Request Summary

- Requesting approval of Final Development Plan, Design Review, and Variances for a 60,000 SF medical office building at the Crescent at Central Park
 - Zoned SCPD – Select Commercial Planned District
 - 9.13-acre site
- Site is directly west of the Crescent Woods apartment complex project

Site Plan

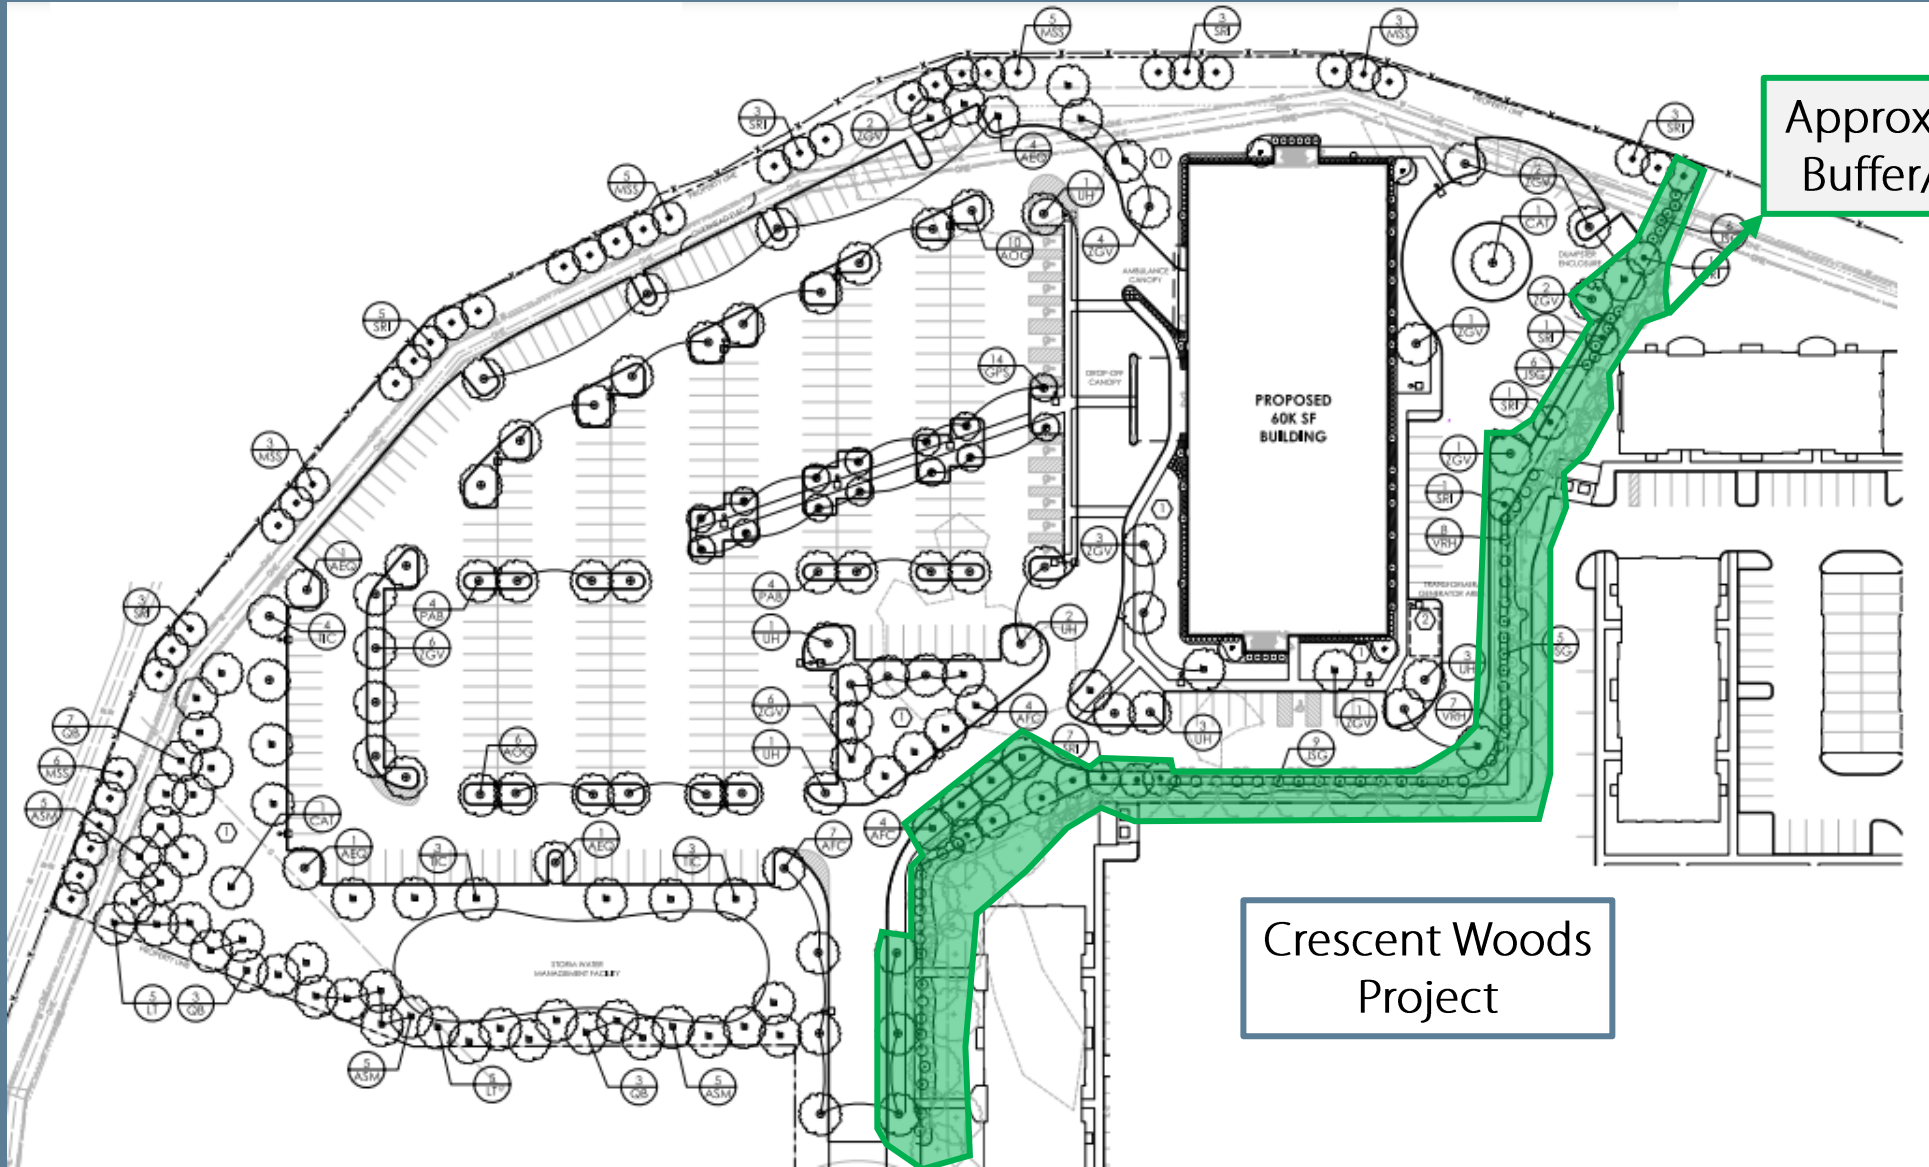
- Requested Variances
 - 1151.04(b)(14) – Development Standards
 - Code requires a 25 ft setback for parking areas adjacent to residential
 - Request to reduce this to 7 ft along the east property line
 - Buffering and screening between parking and residential is coordinated with both sites. The buffer will be 15 ft and landscaped
 - 1163.08(h) – Interior Landscaping Requirements
 - Code requires a 10-foot-wide island with screening for every two rows of parking
 - Many variances to this provision have been approved in the past and it is in the process of being removed from Code

- Requested Variances cont.
 - 1167.18 – Screening Requirements
 - Parking areas adjacent to residential shall have screening that is 6-8 ft in height and 80% opacity
 - Buffering and screening between parking and residential is coordinated with both sites. The buffer will be 15 ft and landscaped
 - 1167.20(b)(1) – Property Perimeter Requirements
 - Office zones adjacent to residential requires a 15 ft buffer, 1 tree per 40 ft, and a continuous 6-foot-high screen
 - There will be partial screening on-site. Landscaping and screening is being coordinated with the adjacent site to create continuous screening

- Staff recommends approval of all 5 Variances
 - Multiple are for screening/buffering requirements. These requirements are met when considering the joint screening between this site and the adjacent Crescent Woods site
 - It is Staff's belief that the Variances will not have a negative impact on the surrounding area
- Staff recommends approval of the Final Development Plan
 - All applicable requirements and criteria are met with Variances
- Staff recommends approval of the Design Review
 - Application meets all criteria, although Planning Commission may request modifications to the design of the building
